PROJECT NAME: BROADWAY CORRIDOR PHASE IIIA

DATE: **January 24, 2011**

ADDENDUM NO. 1

END OF ADDENDUM NO. 1
BROADWAY CORRIDOR PHASE IIIA –
MIRAFLORES MITIGATION ENHANCEMENTS

MIRAFLORES ADDENDUM 1, ATTACHMENT "D"

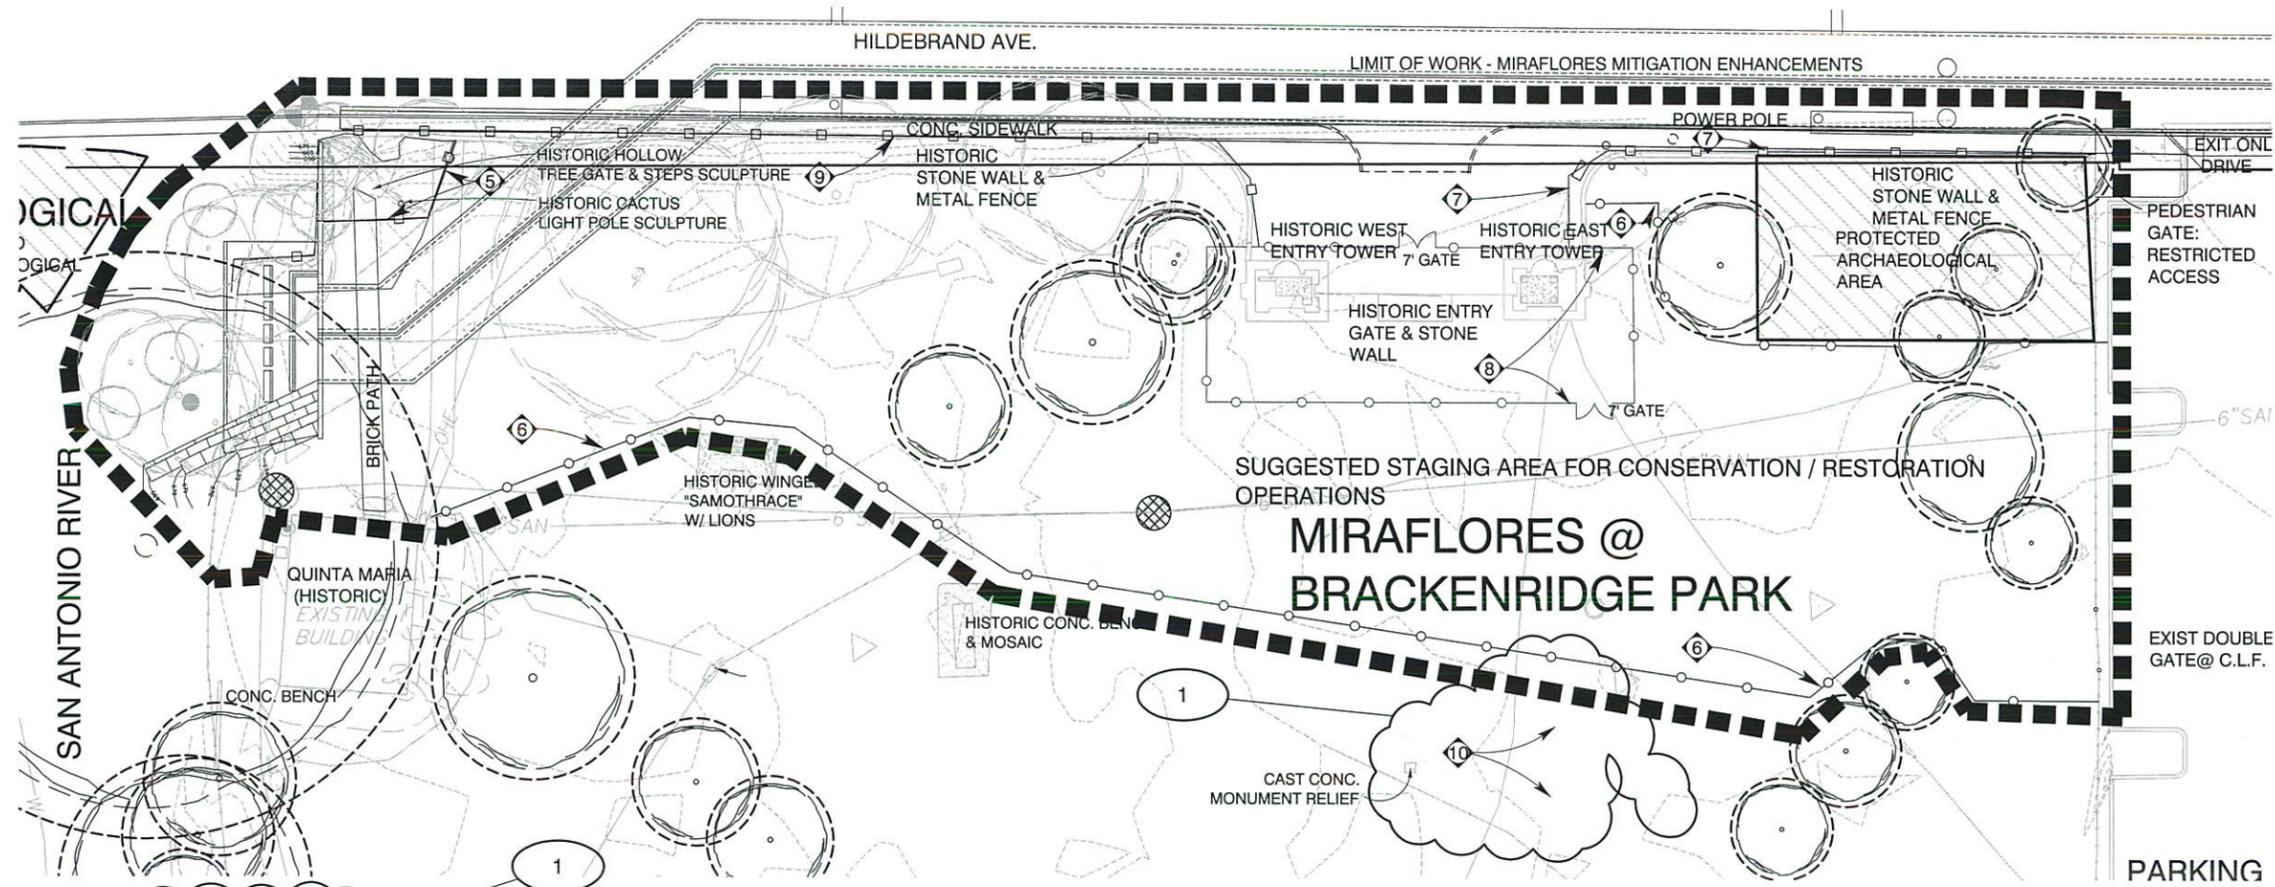
- a. Stabilization and Protections Plan (Attachment "D"):
 - i. Sheet Title revised to "Temporary Stabilization and Protections Plan".
 - ii. Added Note #4: "Contractor shall provide suitable access gates within protection fences with locks for security."
 - 1. Added Keynote No. 10: "Do not conduct any work operation to the south of the construction fence or the delineated limits of construction. Prohibit all workers from entering or walking across this area of Miraflores Park for any reason."
- b. Sign and Ornamental Metal Fence Plan
 - i. Remove Keynote No. 7 and Item 2300.2 from Sheet Totals. See Attachment "E".

3. CONTRACTOR SHALL PROVIDE LOCKED ENCLOSURES FOR CONSERVATION AND RESTORATION STAGING AREAS.
4. CONTRACTOR SHALL PROVIDE SUITABLE GATES WITHIN PROTECTION FENCES, WITH LOCKS FOR SECURITY.

10. DO NOT CONDUCT ANY WORK OPERATIONS TO THE SOUTH OF THE CONSTRUCTION FENCE OR DELINEATED LIMITS OF CONSTRUCTION. PROHIBIT ALL WORKERS FROM ENTERING OR WALKING INTO THIS AREA OF MIRAFLORES PARK FOR ANY REASON.
